Response to the U.S. Nuclear Regulatory
Commission Request for Additional Information on
the Draft Waste-Incidental-to-Reprocessing Evaluation
for the West Valley Demonstration Project
Concentrator Feed Makeup Tank and Melter Feed Hold Tank

September 17, 2012

CH2M Hill-B&W West Valley

for the U.S. Department of Energy, West Valley, New York

Figure 1. CMFT Head Before Flushing

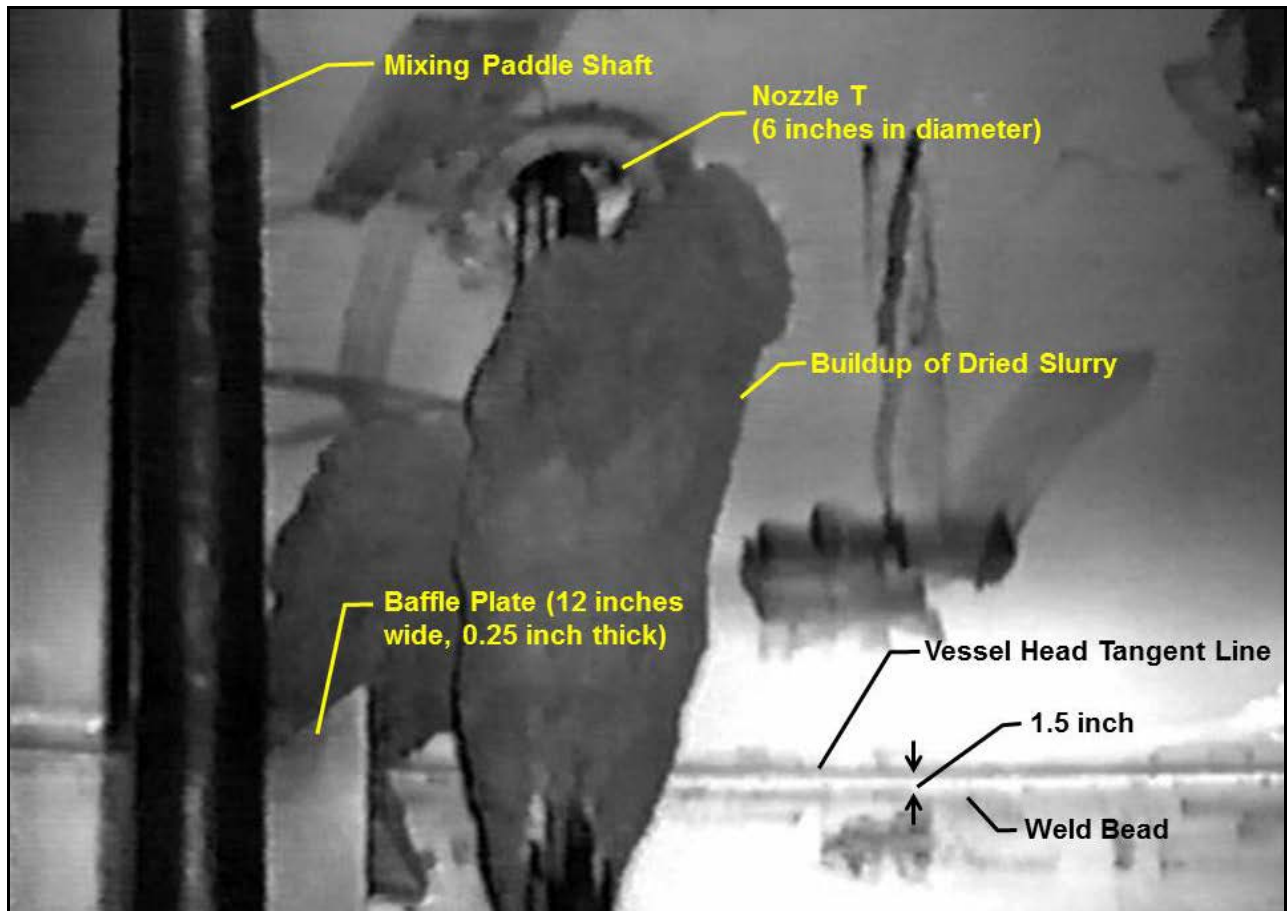
Basis: NUREG-1854, Section 3.3.2, states that the reviewer should verify that reported removal efficiencies are reasonably reliable. The amount of Cs-137 in the vessels prior to flushing assumed an average 0.25 inch thickness in the upper one-third of the vessels and the Cs-137 concentration in the material was assumed to be the same as that in the last batch of slurry sent to the concentrator feed makeup tank before the vitrification system flushing (batch 75), which had the second highest Cs-137 concentration ($1.16 \times 10^4 \mu\text{Ci}/\text{cm}^3$) among the feed material (Kurasch, 2011). However, little detail is provided on why the upper one-third is assumed to be covered in residual material as opposed to some other proportion. There is also not sufficient detail about the volume, and surface area assumptions to reproduce the estimates before flushing provided in Table 4-4. In addition, it should be noted that in using the second highest Cs-137 concentration, DOE may be biased towards overestimating the amount of Cs-137 in the vessels prior to flushing. Since the material remaining in the melter is characterized by using batches 72, 74 and 75, it would be more intuitive to also use this combination of samples to characterize what was in the vessel prior to flushing. Overestimating the amount of activity (curies) before flushing could artificially inflate the reduction factor and is therefore not a conservative approach.

Path forward: Please provide additional support for the activity estimates (curies) before flushing provided in Table 4-4 including the surface area and volume assumptions, further justification for assuming the upper third of the vessels is coated, and a technical basis for assuming the concentration of batch 75 only. Please also discuss the impacts of assumptions on overall conclusions regarding removal to the maximum extent practical.

Photographs showing conditions in the upper portions of the vessels form the basis for the assumed material thickness. Figure 4-2 in the Draft Evaluation shows representative before-flushing images on the interior of both vessels. Figure 1 shows an enlarged view of one of the images in Figure 4-2 of the Draft Evaluation that shows a substantial buildup of dried slurry.
